CTC MEETING # 17
April 9 – 10, 2009

2007/2008 code changes for consideration in the 2009/2010 cycle

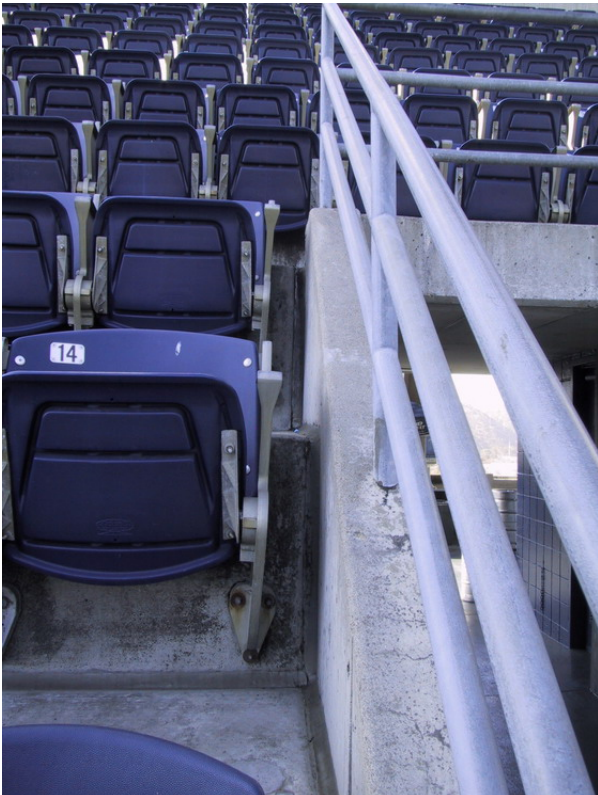
Commenter's Reason: The term "seatboard" that was replaced with the term "fixed seating" should be maintained for several reasons. The term "fixed seating" does not offer any greater clarity in determining the height of a guard than did the original term "seatboard". In fact, the term "fixed seating" offers more confusion. Where do you measure the height of the guard on the fixed seats in these photographs.

Even though the term “seatboard” is not defined in the building code, offering debate about what might be considered a seatboard, neither is the term “fixed seating”. The use of the term “fixed seating” will not end the debate. The term “fixed seating” is used in Section 1108 and elsewhere within the building code in order to determine accessible seating requirements. Therefore, the term “fixed seating” potentially is more limiting than the term “seatboard”. Would it only apply to fixed seating in assembly seating if it stands as written? This is not the proponent’s intent. The proponent’s reason stated that “a fixed seat becomes a walking surface to a child and thus warrants the guard height to be measured from that point.” While this would certainly be true for some cases, it is not true in all cases. The “seatboards” in the following photographs certainly become a walking surface and measurable. The fixed seating in the photographs above is not.

1013.2 (IFC [B] 1013.2) (Supp) Height. Required guards shall be not less than 42 inches (1067 mm) high, measured vertically above the adjacent walking surfaces, adjacent ~~fixed seating~~ seatboard or the line connecting the leading edges of the treads.

FIGURE 1614.4
LONGITUDINAL, PERIMETER, TRANSVERSE AND VERTICAL TIES

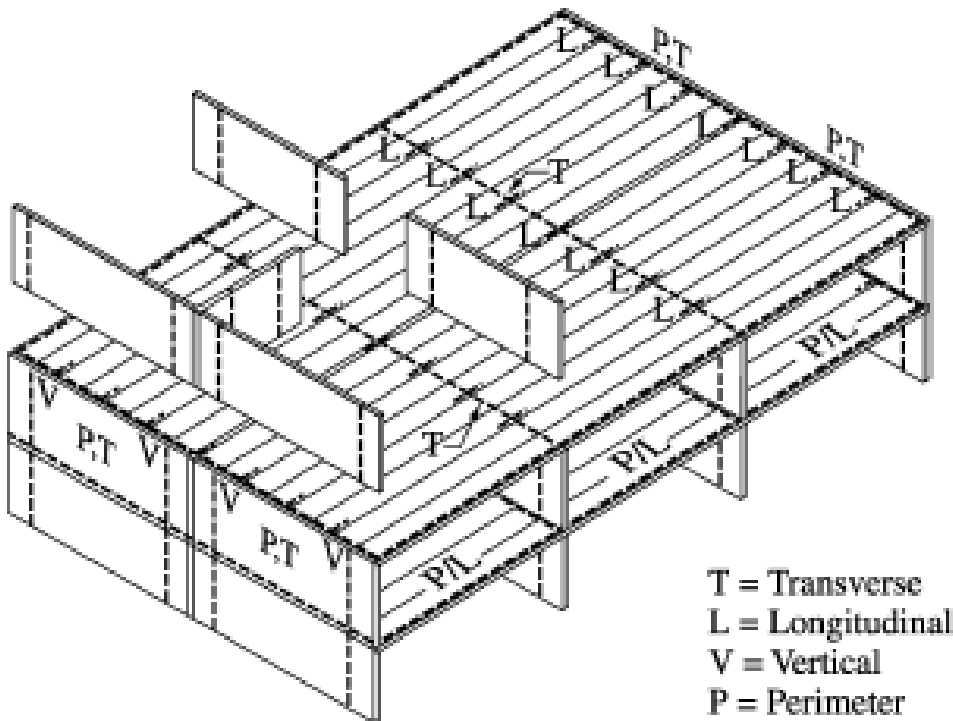
Commenter's Reason: Reason: As noted in the reason for disapproval, there is a need for structural integrity provisions in the code and the reason further states that the provisions would involve too many buildings that do not have integrity issues. The CTC concurs with this philosophy - the need for such provisions should be a function of the relative risk. Low rise buildings which typically employ a less sophisticated structural system do not represent the same risk as taller buildings such as high rise buildings. Further, inclusion of Category II buildings also represents a large volume of buildings which would envelope a large population of buildings without detailing the risk. Category III buildings which are noted in Table 1604.5 of the code as "representing a substantial hazard to human life in the event of failure" such as high occupant load buildings, as well as Category IV buildings which are classified as "essential facilities" such as hospitals, warrant such provisions.

This public comment responds to these two fundamental issues by limiting the application to only Category III and IV buildings which are considered high rises.

Sections 164.4.2.1, 1614.4.2.3 and 1614.4.3.4 are correspondingly revised to remove the reference to wood construction as the application is now limited to high rises for which wood bearing walls would not be permitted based on type of construction.

α_T = a coefficient with a value of 1,500 lb/ft (2.25 kN/m) for masonry bearing wall structures and a value of 375 lb/ft (0.6 kN/m) for structures with bearing walls of ~~light wood or cold formed steel frame construction.~~

β_T = a coefficient with a value of 16,000 lbs (7,200 kN) for structures with masonry bearing walls and a value of 4,000 lbs (1,300 kN) for structures with bearing walls of ~~light wood~~ or cold formed steel frame construction.

1614.4.3.4 Vertical ties. Vertical ties shall consist of continuous or spliced reinforcing, continuous or spliced members, wall sheathing or other engineered systems. Vertical tension ties shall be provided in bearing walls and shall be continuous over the height of the building. The minimum nominal tensile strength for vertical ties within a bearing wall shall be equal to the weight of the wall within that story plus the weight of diaphragm tributary to the wall in the story below. No fewer than two ties shall be provided for each wall. The strength of each tie need not exceed 3,000 lb/ft (450 kN/m) of wall tributary to the tie for walls of masonry construction or 750 lb/ft (140 kN/m) of wall tributary to the tie for walls of ~~light wood~~ or steel frame construction.
